FAIRLIGHT BOARDING HOUSE

195-197 SYDNEY ROAD FAIRLIGHT NSW 2094

S4.55 SUBMISSION

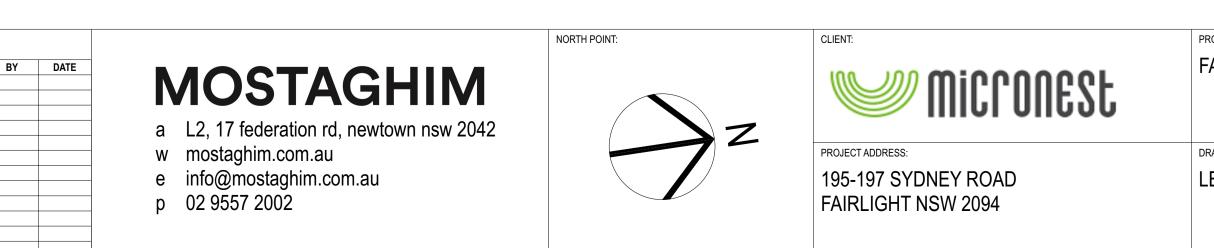
AT DRIVEWAY ENTRY.	SISTENT WITH REVISED STORMWATEF					
PROJECT TITLE:	DRAWN BY:	CHECKED BY:					
FAIRLIGHT BOARDING HOUSE	MO, LN & KL	MO					
	100 mm ACTUAL						
	(100 mm) EXACTLY, THIS DRAV	ES NOT MEASURE ONE HUNDRED MIL VING WILL HAVE BEEN ENLARGED OR ING ALL LABELED SCALES.					
DRAWING TITLE:	SCALE:	PROJECT NUMBER:					
LEVEL 1 PLAN	1:100 @ A1	20025					
	A disc	A01.01 stage / dwg no.	B

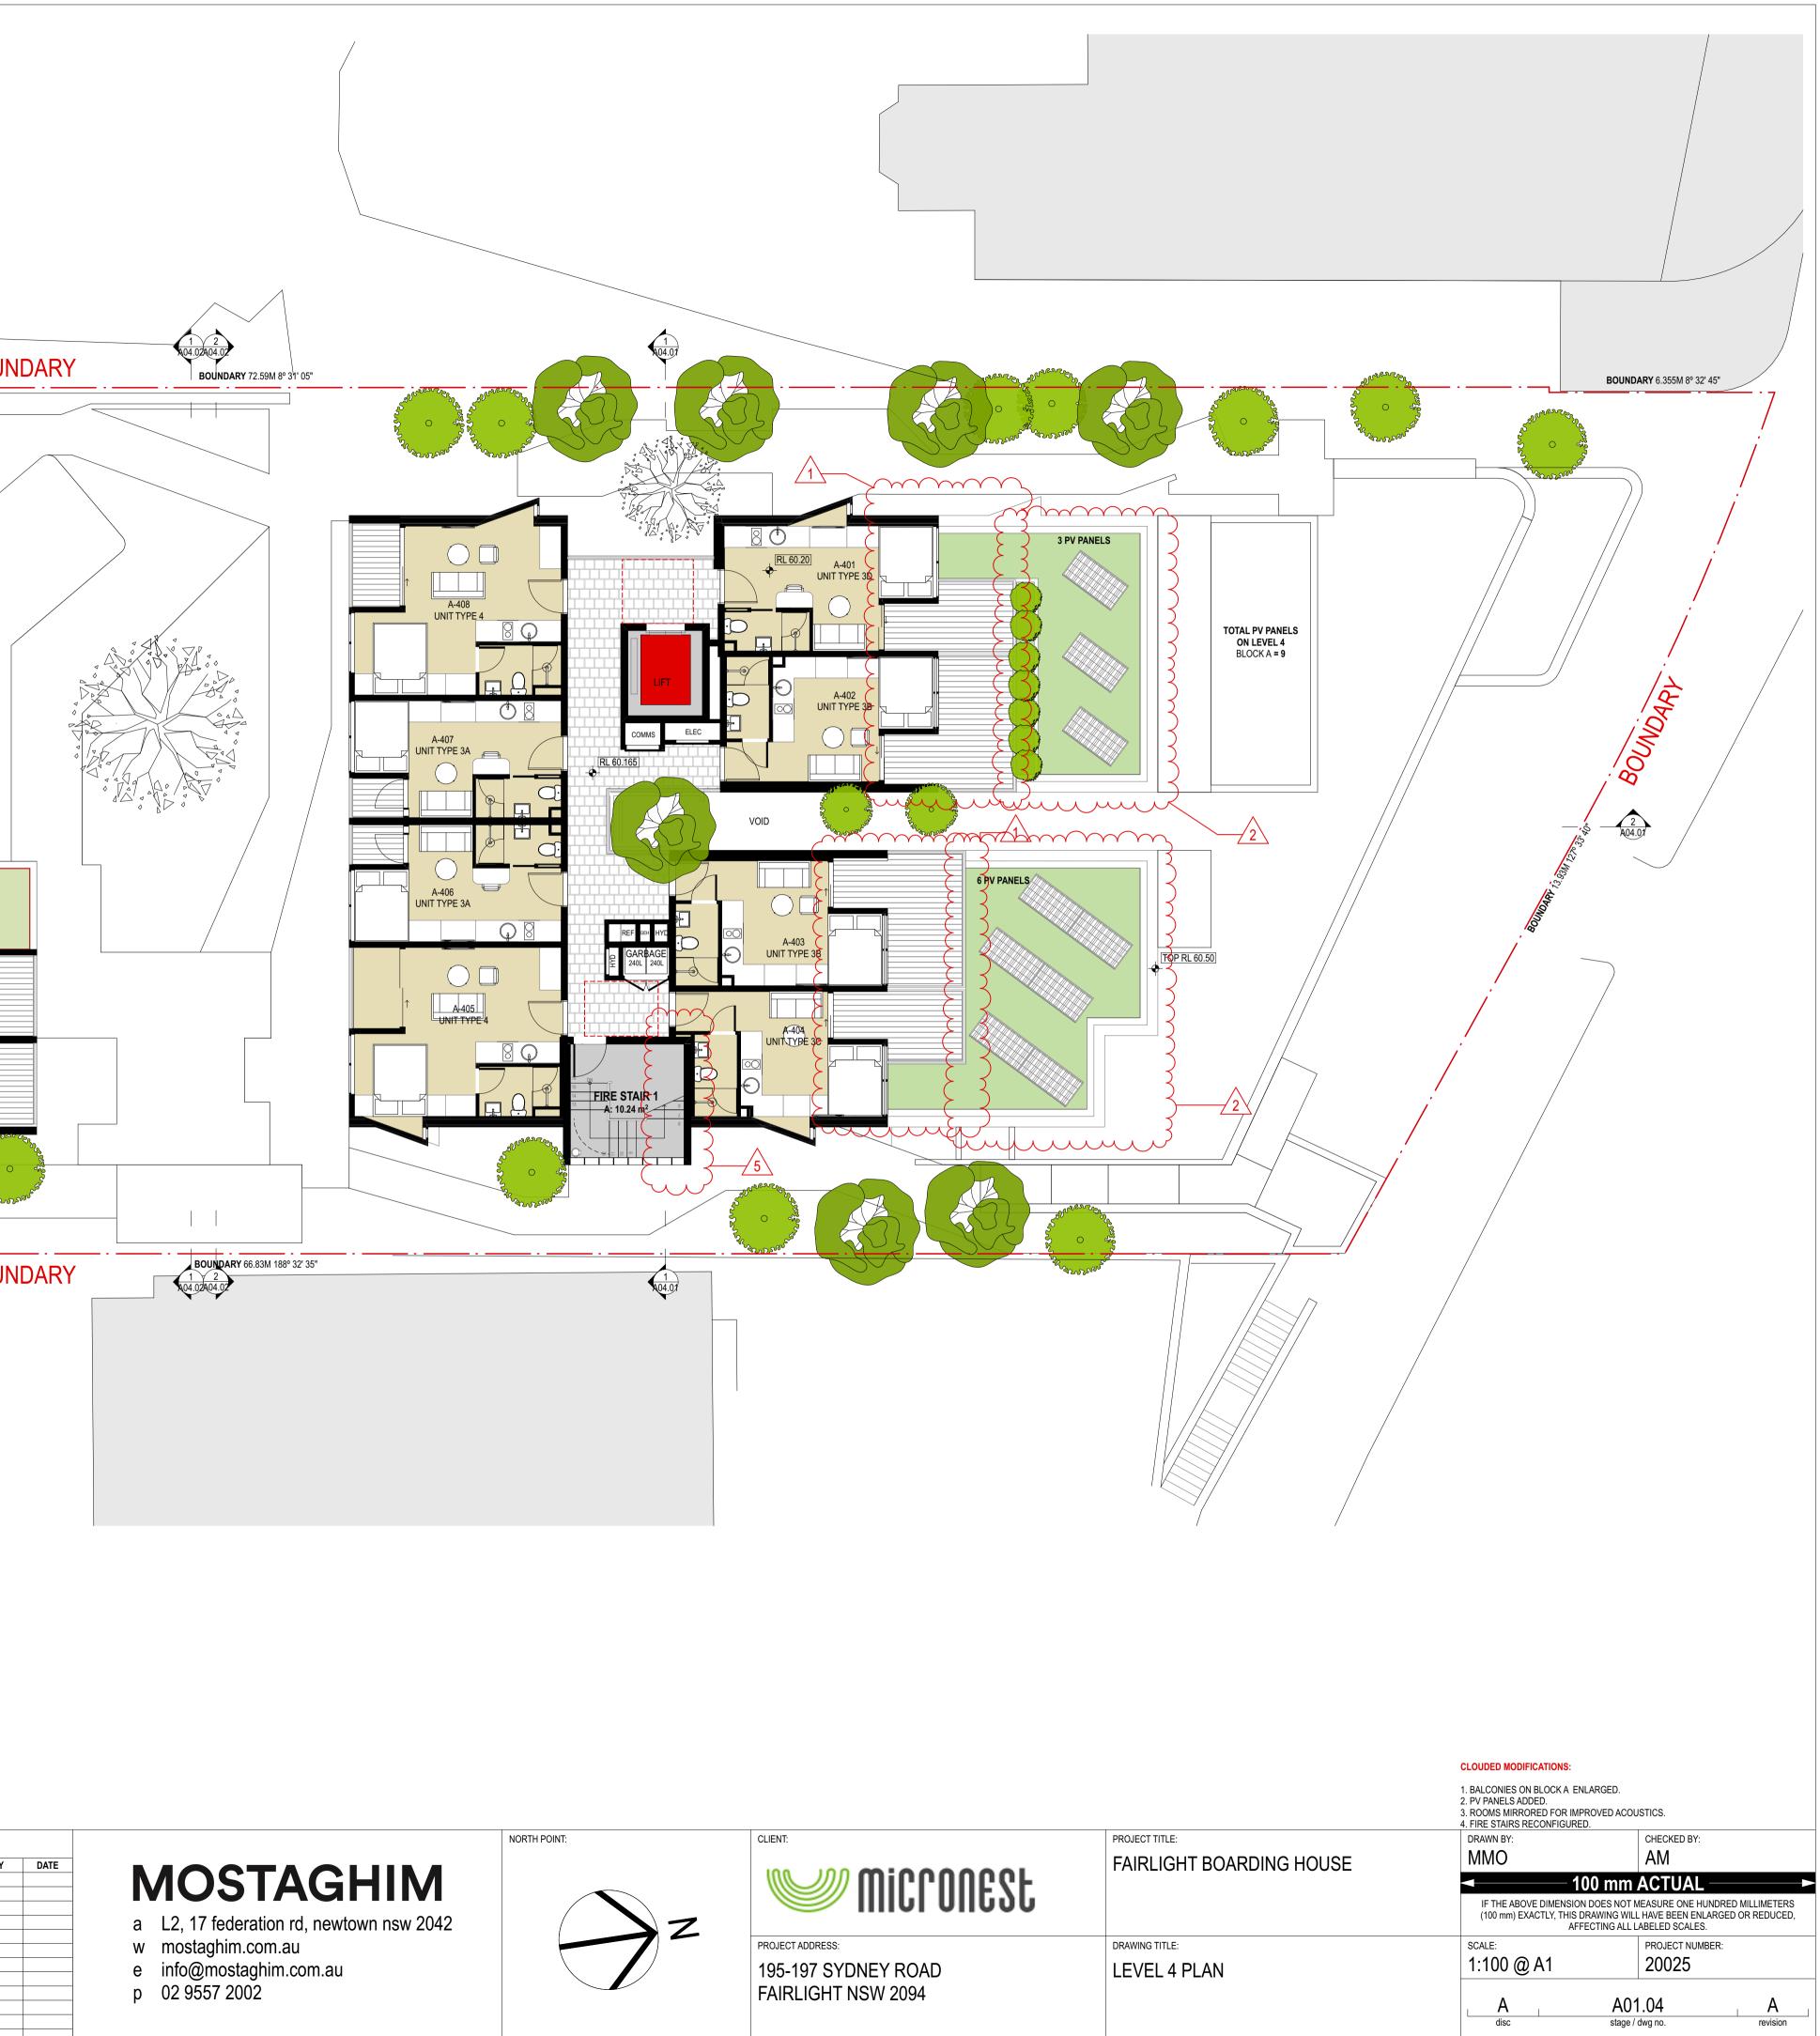
1. PV PANELS ADDED TO ROOF TO 2. AMEND TO COMPLY WITH WHEE 3. FIRE STAIR RECONFIGURED.	PS. L CHAIR TURNING CLEARANCE REQUIREMENT.				
PROJECT TITLE:	DRAWN BY:	CHECKED BY:				
FAIRLIGHT BOARDING HOUSE	MMO	AM				
	– —100	mm ACTUAL				
	IF THE ABOVE DIMENSION DOES NOT MEASURE ONE HUNDRED MILLIMETERS (100 mm) EXACTLY, THIS DRAWING WILL HAVE BEEN ENLARGED OR REDUCED, AFFECTING ALL LABELED SCALES.					
DRAWING TITLE:	SCALE:	PROJECT NUMBER:				
LEVEL 5 PLAN	1:100 @ A1	20025				
	disc	A01.05 A stage / dwg no. revision

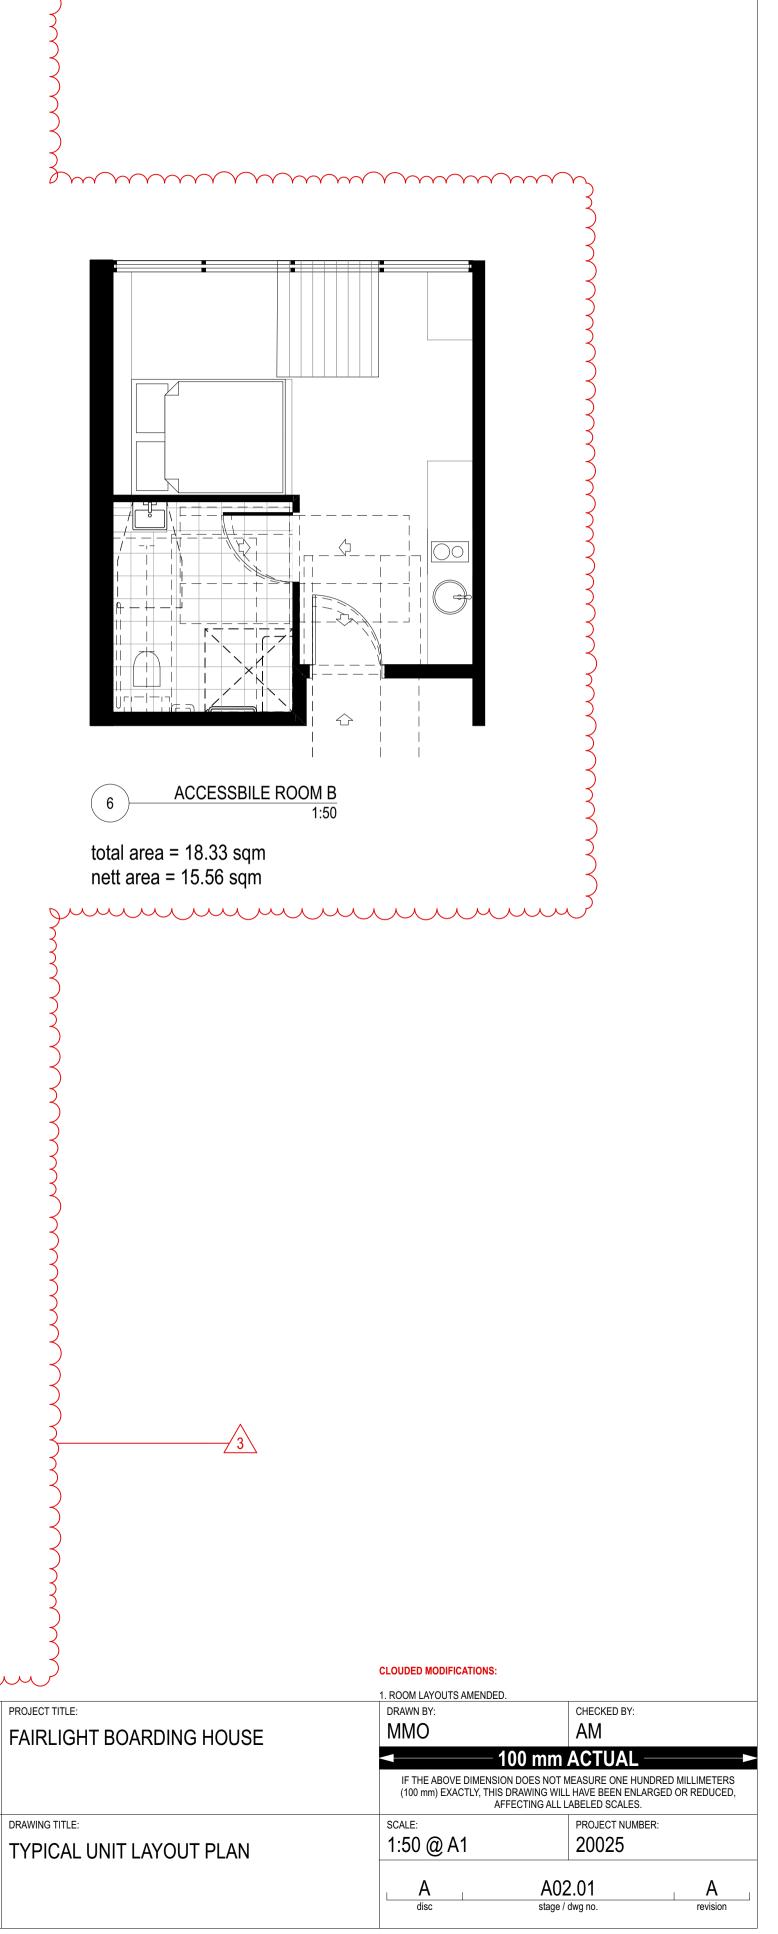
CLOUDED MODIFICATIONS:

FIRE BOOSTER/HYDRANT, GAS METER & V AMENDED FOR COMPLIANT. FINISHES No. 7 AMENDED FROM SCREEN I FRL 90 MINS COMPLIANT. CHANGE DOUBLE HINGED GARAGE FULL I 4. RAISE WALL TO ACHIEVE 3500mm CLEARA 5. ADD GATE. 	BLOCKS TO GLASS BLOCKS FOR HEIGHT DOOR TO A ROLLER DOOR.				
PROJECT TITLE:	DRAWN BY:	CHECKED BY:				
FAIRLIGHT BOARDING HOUSE	MO, LN & KL	MO				
	100 mm ACTUAL ————————————————————————————————————					
	IF THE ABOVE DIMENSION DOES NOT M (100 mm) EXACTLY, THIS DRAWING WILL AFFECTING ALL L	HAVE BEEN ENLARGED OR REDUCED,				
DRAWING TITLE:	SCALE:	PROJECT NUMBER:				
ELEVATION NORTH + SOUTH	1:125, 1:1 @ A1	20025				
	A A03	-

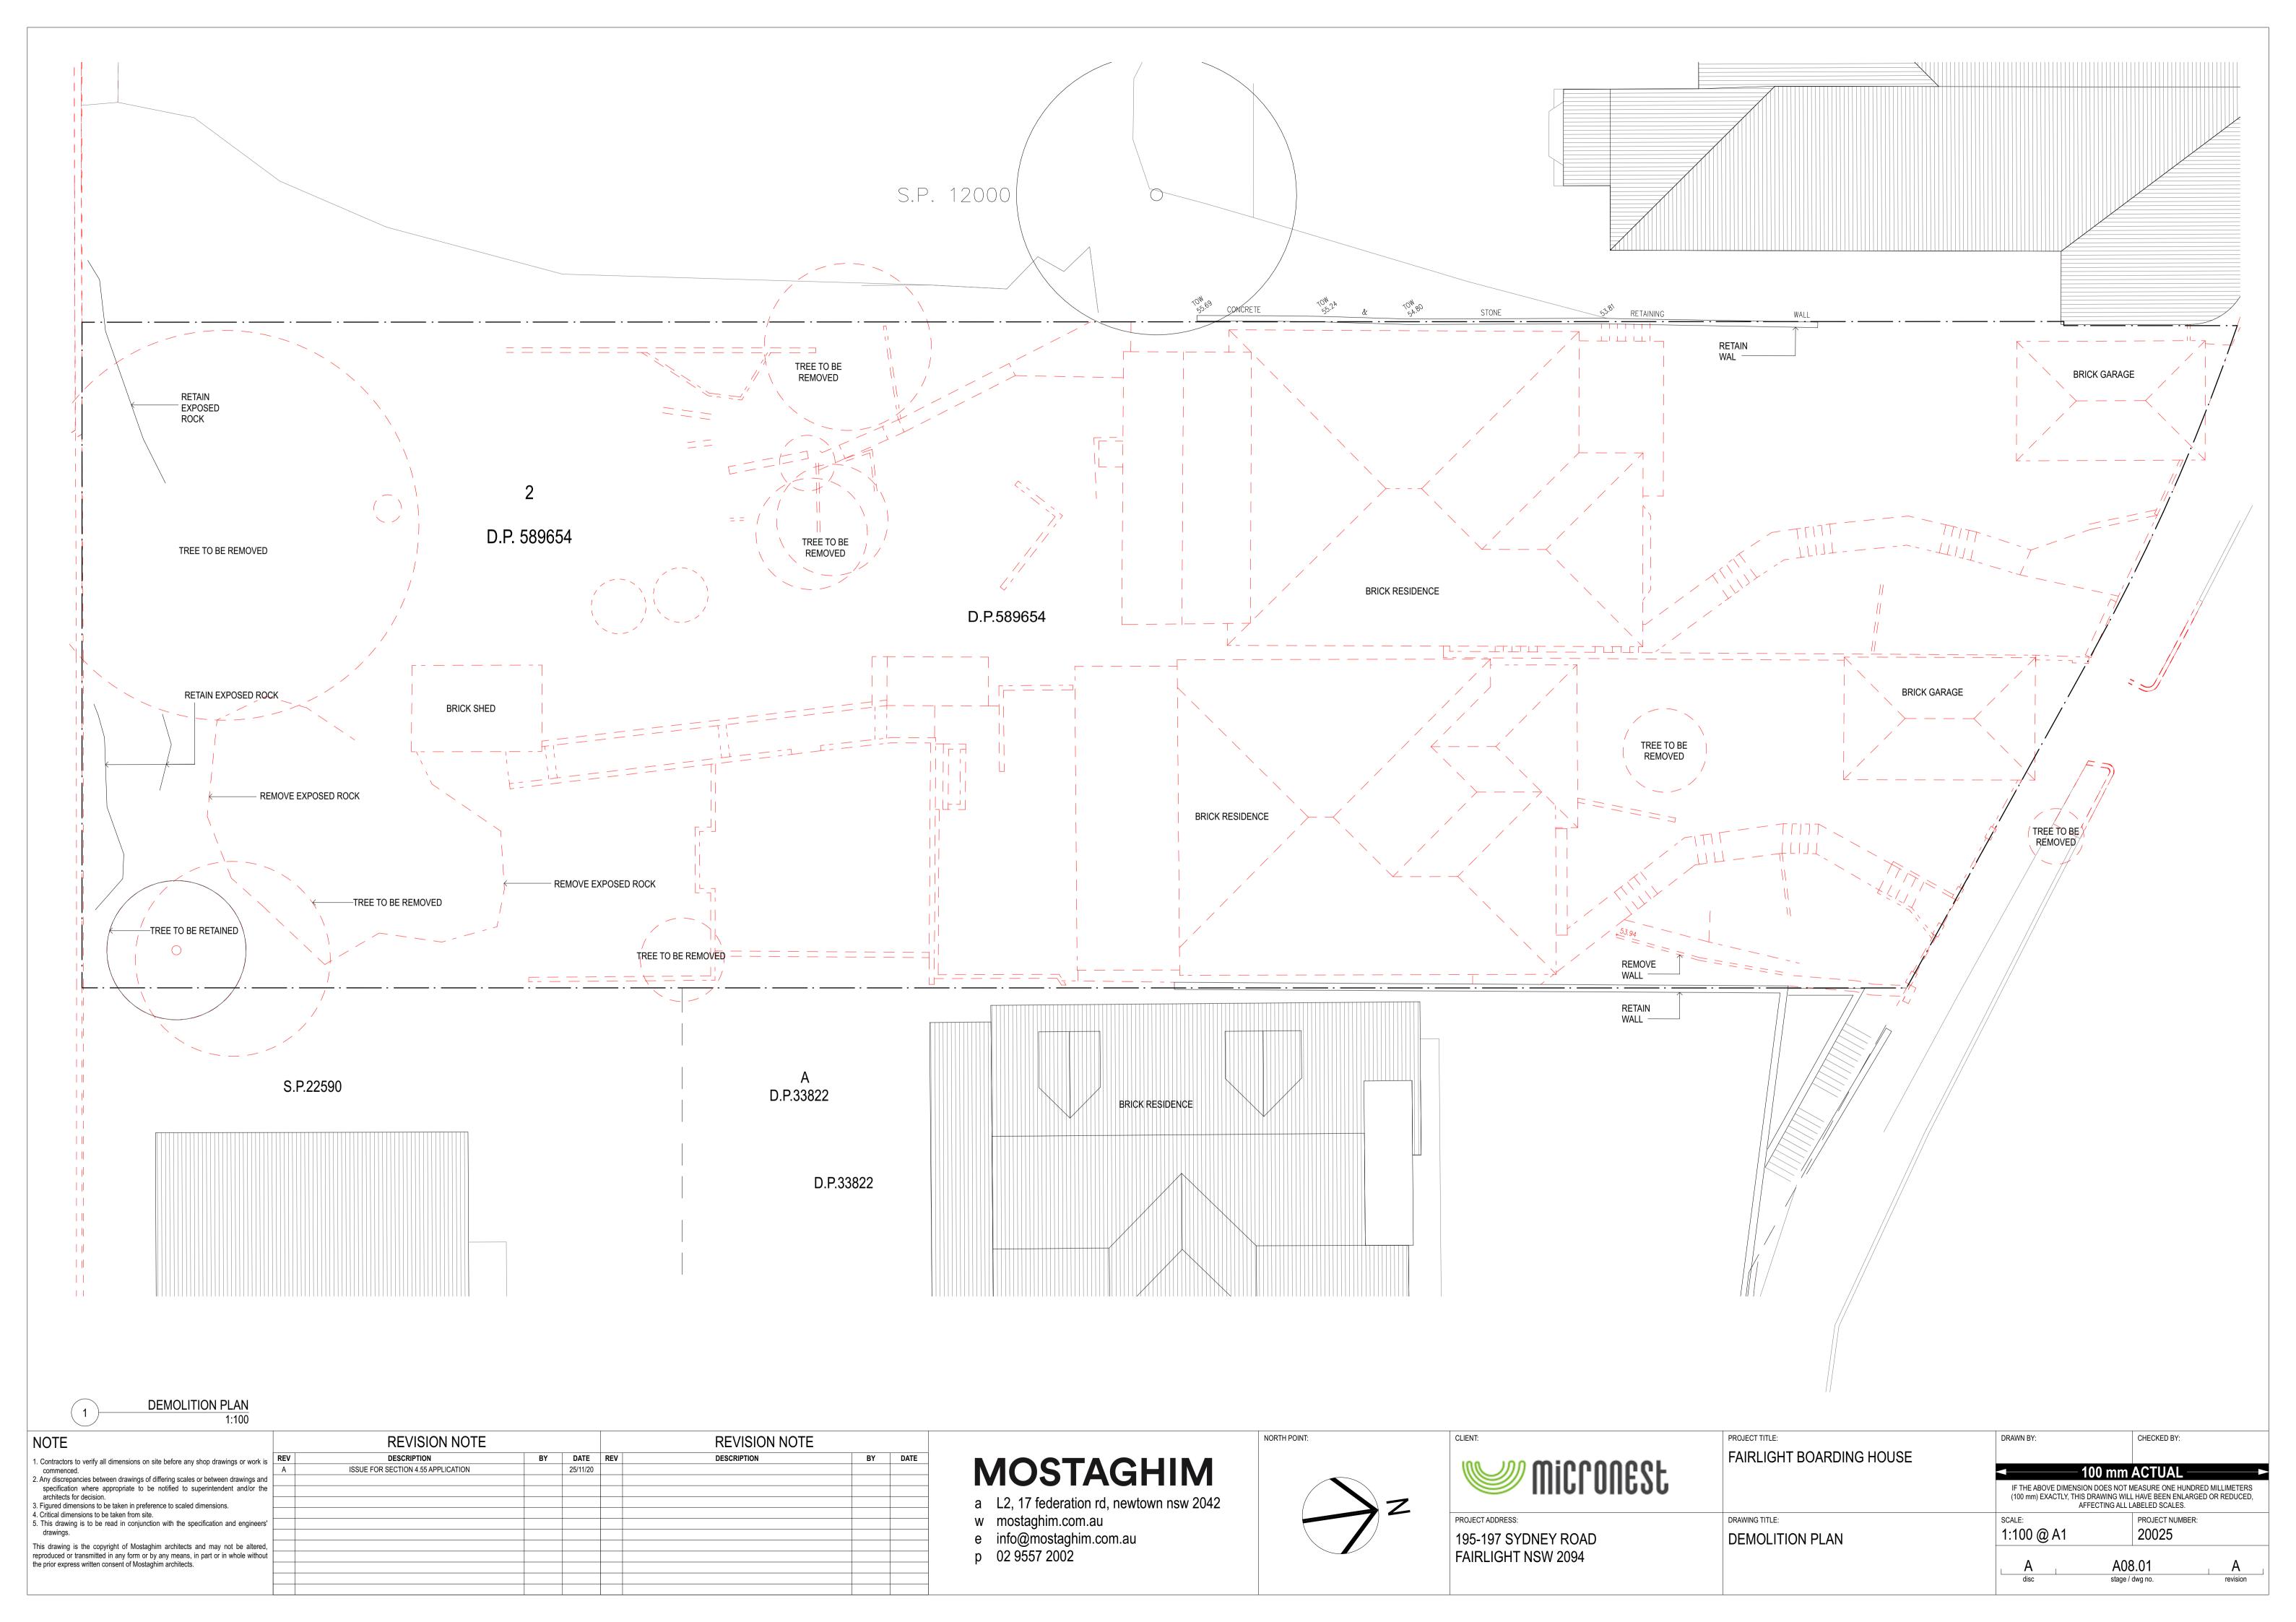
1. CARPARK ENTRY RAMP ADDED & ASSOCI 3500mm CLEARANCE TO WASTE TRUCK. 2. REMOVE RETAINING WALL AND REPLACE 3. FINISHES No. 7 AMENDED FROM SCREEN FRL 90 MINS COMPLIANT.	WITH NATURAL ROCK FACE WALL.				
PROJECT TITLE:	DRAWN BY:	CHECKED BY:				
FAIRLIGHT BOARDING HOUSE	MO, LN & KL	МО				
	100 mm ACTUAL					
	IF THE ABOVE DIMENSION DOES NOT N (100 mm) EXACTLY, THIS DRAWING WILI AFFECTING ALL L	HAVE BEEN ENLARGED OR REDUCED,				
DRAWING TITLE:	SCALE:	PROJECT NUMBER:				
SECTION A-A + SECTION B-B	1:125, 1:1 @ A1	20025				
	A A02 disc stage /
